Former Odeon Site and Rosenheim Building - 2019/3686/P

Delegated Report (Members Briefing)		Analysis sheet	Expiry Date:	13/09/2019
		N/A	Consultation Expiry Date:	11/09/2019
Officer			Application Number(s)	
David Peres Da Costa			2019/3686/P	
Application Address			Drawing Numbers	
Former Odeon Site and Rosenheim Building 25 Grafton Way London WC1E 6DB			Refer to Draft Decision Notice	
PO 3/4	Area Team Signature	C&UD	Authorised Officer Signature	
Proposal(s)				
Details of acoustic report setting out pre-installation details of plant equipment, as required by part of condition 28 of planning permission 2013/8192/P, dated 22/09/2014 (as amended by 2015/2771/P dated 18/09/2015), for the redevelopment of the former Odeon site and demolition of the Rosenheim Building to provide a Proton Beam Therapy (PBT) cancer treatment facility and day surgery facilities.				
Recommendation(s):	Grant approval of details (in part)			
Application Type:	Approval of details

Details of acoustic report setting out pre-installation details of plant equipment, as required by part of condition 28 of planning permission 2013/8192/P, dated 22/09/2014 (as amended by 2015/2771/P dated 18/09/2015), for the redev

General Arrangement Showing L4 and L6 Roof Plant

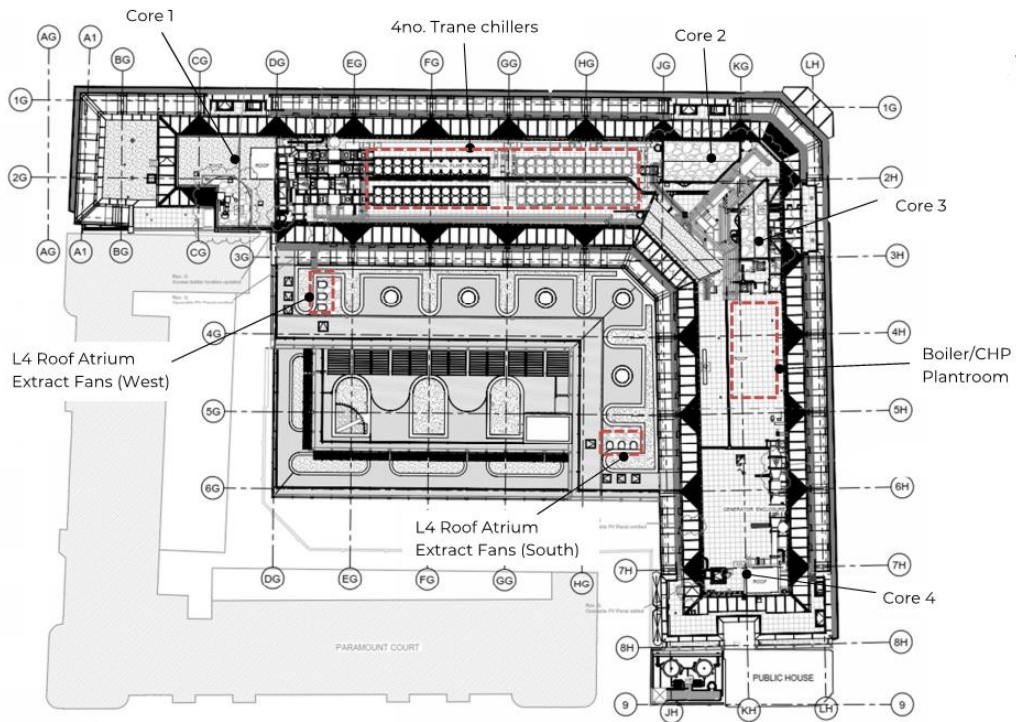
CAAC/Local groups* comments: *Please Specify	<p>Grafton Way Tenants and Residents Association - object</p> <p>The 30-40 Grafton Way Tenants and Residents Association asks that Condition 28 not be discharged. In the acoustic report we do not see reference to our building which runs directly opposite the Proton site, for most of its length. The report speaks only of flats at the top of the neighbouring building, Maple House. 30-40 Grafton Way has 134 flats, with less than half that number being directly opposite the UCH development. Our flats are located from 1st to 8th floors.</p> <p>Low-level constant noise is not acceptable. Although the acoustic report states high levels of background noise this is not continuous, we treasure the moments of silence, of course we had many more of these before the preparatory work for the UCLH development commenced.</p>

It is unclear to me if by requesting discharge of this condition that UCLH are trying to get away with the requirement to do noise checks after installation and before handover to show compliance with the standards in the report? If so what measures will they have to apply to attenuate the noise and how are they proposing to control it? If it is found our residents have an increase in noise this must be mitigated immediately, BEFORE the hospital becomes operational.

- 2.5. Additional ventilation plant, chillers, boilers and medical gas plant would be located at Level 6 roof on the buildings fronting Grafton Way and Huntley Street. Ventilation fans would be arranged around risers located in Cores 1, 2 (Grafton Way west and east, respectively) and Cores 3 and 4 (Huntley Street north and south, respectively). Four chillers would be positioned on the Grafton Way building roof between Cores 1 and 2. A CHP/boiler plant room would be located to the south of Core 3.

- 2.6. The L6 roof would be fitted with visual screens approximately 3m high. These will be formed of areas of photovoltaic cells interspersed with architectural louvres. Cross-flow of air will not generally be required, such that louvres can be covered at the rear, creating an acoustic barrier at the roof edge on all sides.

Officer's comment: The acoustic report has been amended so that it explicitly refers to 30-40 Grafton Way. The submitted report indicates the overall plant noise level from the plant areas would comply with the noise thresholds set out in condition 28 of planning permission 2013/8192/P (i.e. 5dB(A) below the existing background noise). The submitted details have been reviewed by Environmental Health and demonstrate that the amenities of the adjoining premises and the area generally would be safeguarded. See para 2.10-2.13 below.

In relation to the concern that noise checks before handover are being avoided, condition 28 of the parent permission 2013/8192/P includes a requirement for a further noise survey to be submitted on commissioning the machinery and prior to the building being occupied. An informative would be included to remind the applicant of this requirement. See para 2.13 below.
